SUBJECT: Forwards response to request for addl info related to proposed changes to Nine Mile Point Unit 1 re pressure-temp limits. Nonproprietary version of Final Rept MPM-59401-NP encl also.

*Subject:       Proposed License Amendment - New Pressure-Temperature Limit Curves,  
              Response to Request for Additional Information*

### Response to NRC Additional Information Request Related to Proposed Changes to Nine Mile Point Unit 1 (NMP-1) Pressure-Temperature Limits

Figure 1 Unirradiated (Top) and Irradiated (Bottom) Yield Strength vs. Weight Percent Copper

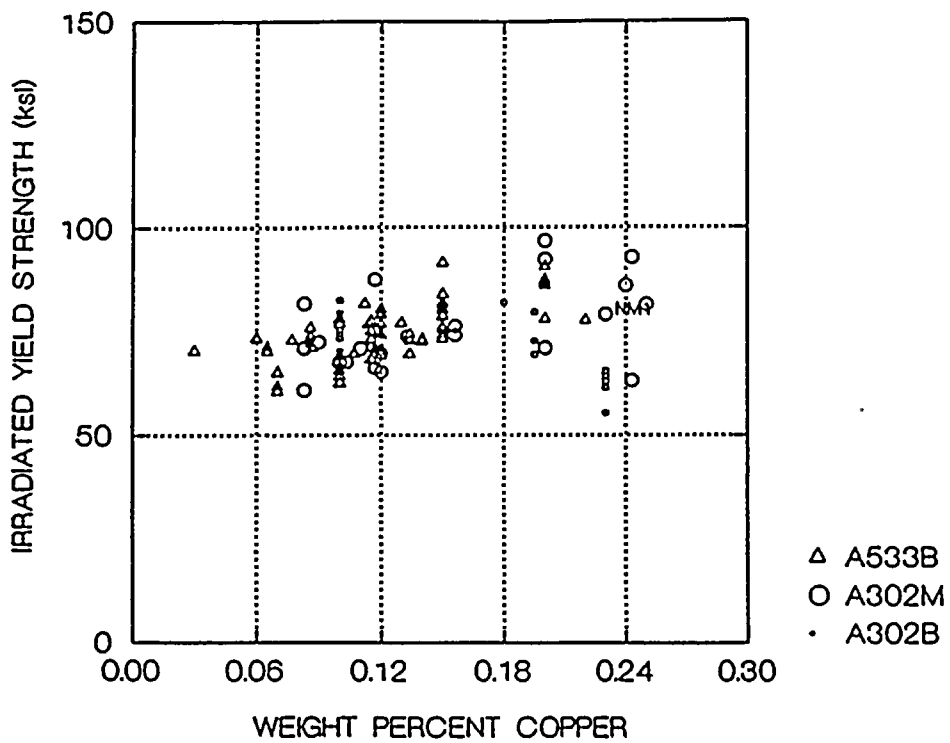
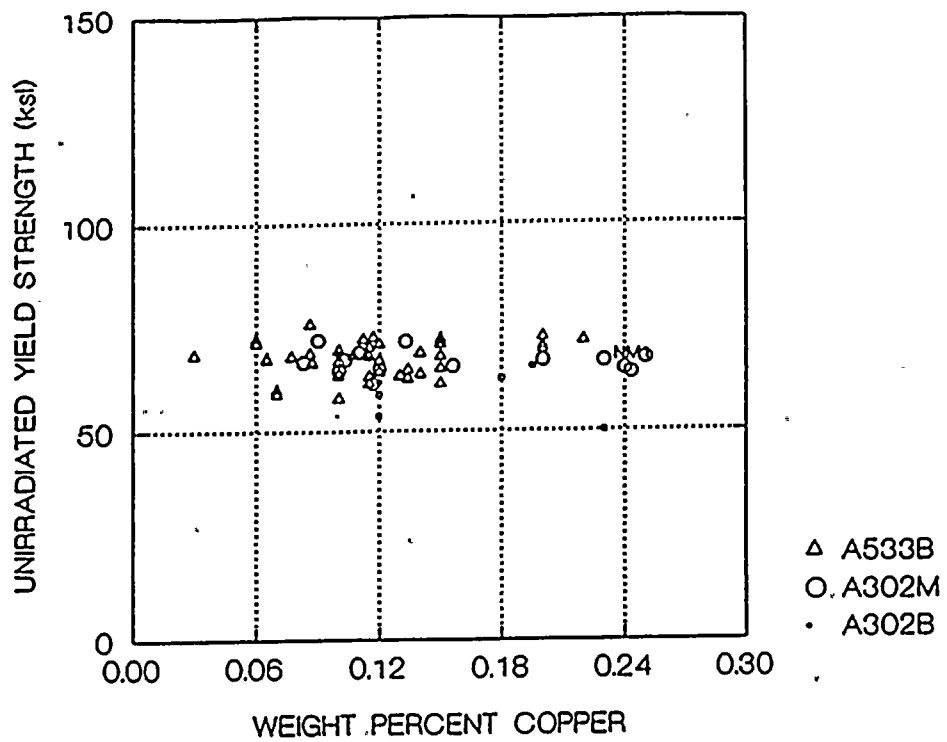
**Information Request D** - "Provide the basis and data used to conclude that "... most BWRs operate at fluences below the fluence threshold for significant Cu precipitation." (Page 3 of submittal)"

Figure 1 shows that elevation of the yield strength occurs for Cu levels above  $\sim 0.1$  weight percent. This is consistent with the Transmission Electron Microscopy (TEM), Atom Probe-Field Ion Microscopy (APFIM), and Small Angle Neutron Scattering (SANS) data reported in Reference [Au94]. The change in yield strength as a function of fluence and Cu content is shown in Figures 2 through 5. As shown in Figure 3, for fluences  $< 1 \times 10^{18}$  n/cm<sup>2</sup>, there is no significant dependence of Cu level on the yield strength elevation. Figure 6 shows the  $\Delta T_{30}$  and  $\Delta USE$  correlation with elevation of yield strength ( $\Delta \sigma_y$ ). The correlation of  $\Delta \sigma_y$  with  $\Delta T_{30}$  is a reflection of the neutron induced formation of fine scale dislocation obstacles which increase the flow stress and produce more intense localized plastic zones at elevated temperature. This correlation is physically meaningful. However, the correlation of  $\Delta USE$  with  $\Delta \sigma_y$  is an indirect correlation. The drop in USE is not directly related with hardening. Rather, flow localization due to the introduction of shearable defects is the most plausible explanation for the shelf drop [Ma94b]. The fact that the  $\Delta USE$  correlates with  $\Delta \sigma_y$  is merely a reflection that  $\Delta \sigma_y$  is proportional to the number density of shearable defects.

Figure 10 A302B Plant-Specific Data Set Showing Lack of Dependence of Charpy Shift on Cu Content in the Low Fluence Range. (Cu Content in Weight % Shown Next to Each Datum)

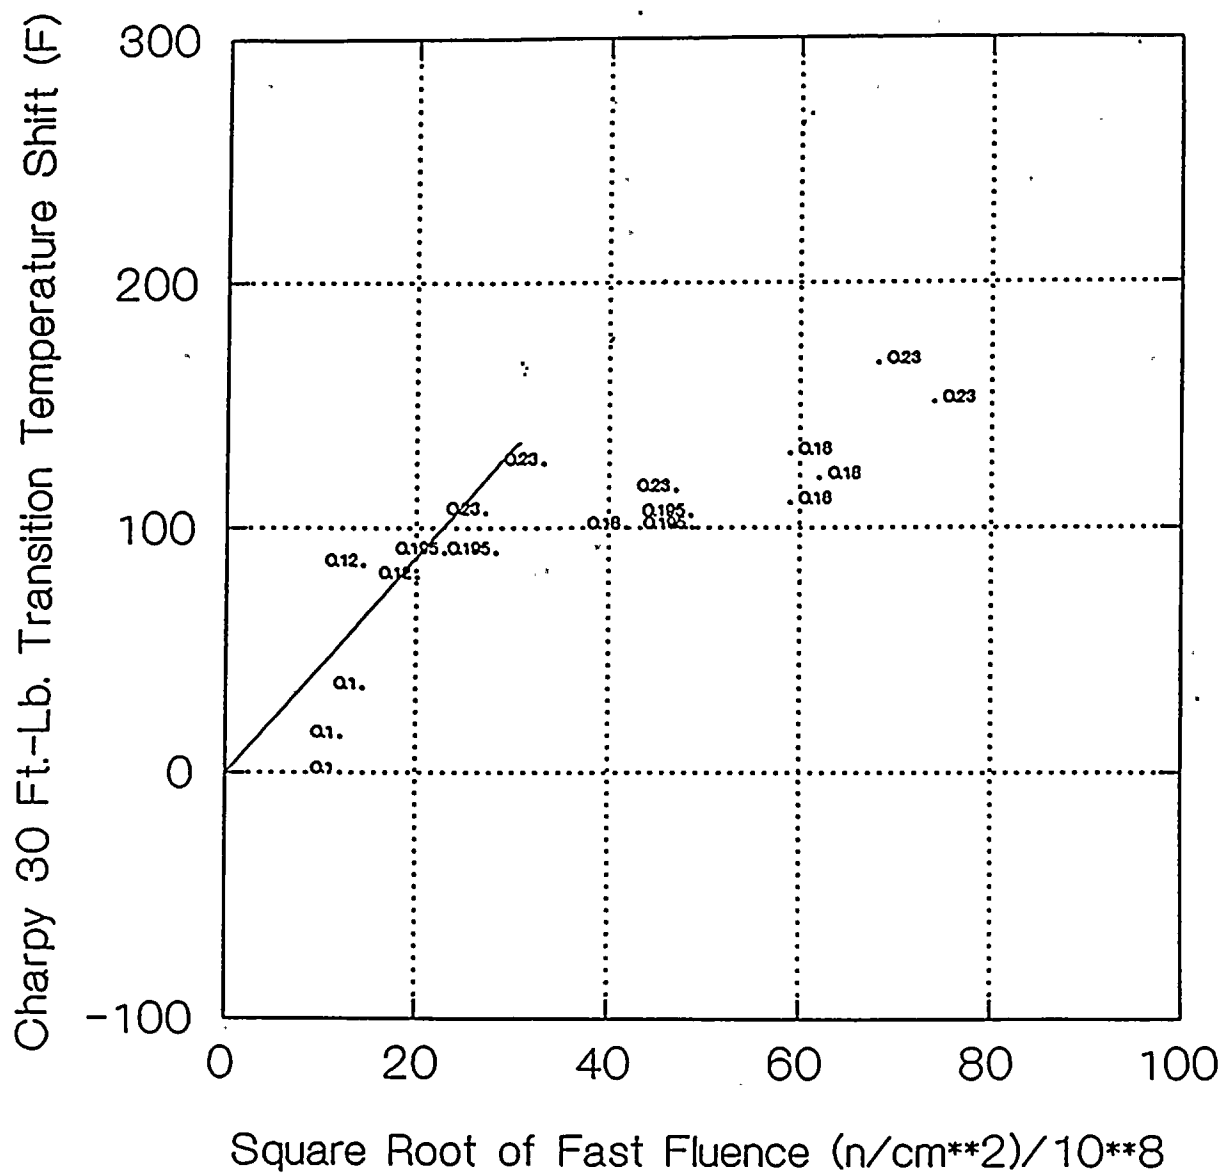
**Information Request C** - "Figure 2-1 on Page 11 of the submittal compares the RG 1.99, Rev. 2 model with the plant specific  $\Delta RT_{NDT}$  model. For each data point:

- (1) Provide the copper and nickel content,
- (2) Identify the plant from which each data point was obtained, and
- (3) Identify which data were not used in development of the curve."

**NMPC Response** - The Cu and Ni content of the data plotted in Figure 2-1 on Page 11 of the submittal is given in Table 1. The Cu content of the data in Table 1 was plotted versus the square root of fluence in Figures 4-10 through 4-12 of Reference [Ma94]. These plots demonstrate the lack of Cu dependence at fluences below  $\sim 2 \times 10^{18}$  n/cm<sup>2</sup>.

In addition to the tensile data trends, further evidence of a lack of Cu dependence at fluences below  $\sim 2 \times 10^{18}$  n/cm is shown in Figures 10-12. There is no apparent trend in Charpy shift with fast fluence in these figures.

Figure 13 Plant-Specific Charpy Shift Model With 2σ Confidence Limits

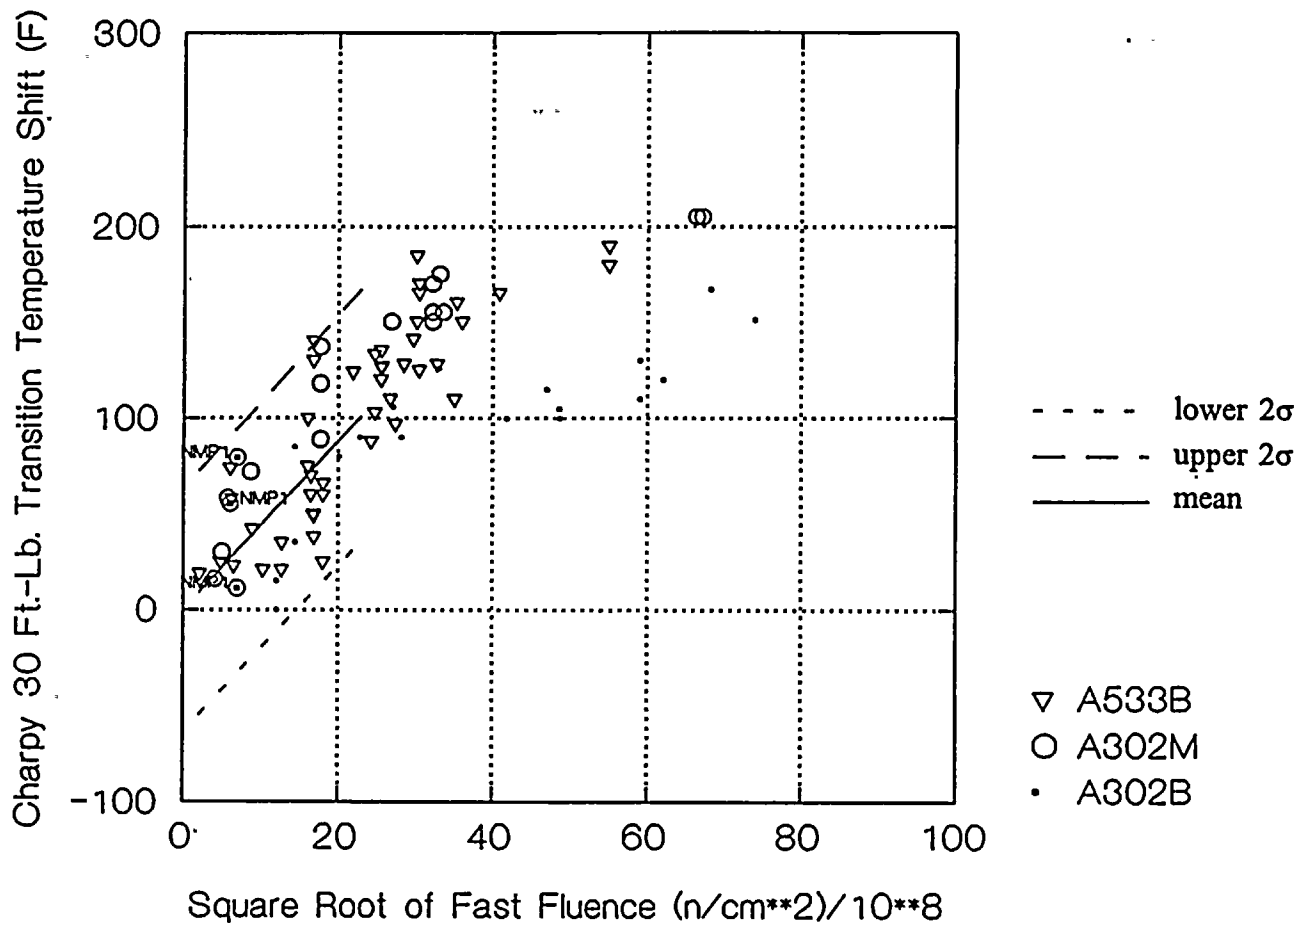
- $\sigma_I$  and  $\sigma_\Delta$  used for the weld margin term calculation.
- Standard deviation for the plant-specific plate model.

In response to the NRC request, the standard deviation ( $\sigma$ ) for the plant-specific plate model was calculated and found to be 32°F. The mean regression line and  $2\sigma$  confidence limits are shown in Figure 13. It is NMPC's position that the most appropriate  $\sigma_\Delta$  is that of RG1.99(2) (17°F) because it was calculated based on a large data population and more accurately reflects the uncertainty in Charpy shift ( $\Delta T_{30}$ ) measurement and material variation. Further justification for use of the RG1.99(2)  $\sigma_\Delta$  term is provided by considering the variation in the NMP-1 surveillance data. The average for the three NMP-1  $\Delta T_{30}$ s is 48.5°F. The difference between this average and the peak  $\Delta T_{30}$  is 30.8°F. The difference between the average and the lowest  $\Delta T_{30}$  is 37.3°F. These data, along with the data presented in Table 1, demonstrate the lack of dependence on Cu in the low fluence range and also suggest that the RG1.99(2)  $2\sigma$  limit (34°F) reasonably represents the uncertainty for the NMP-1 beltline plates.
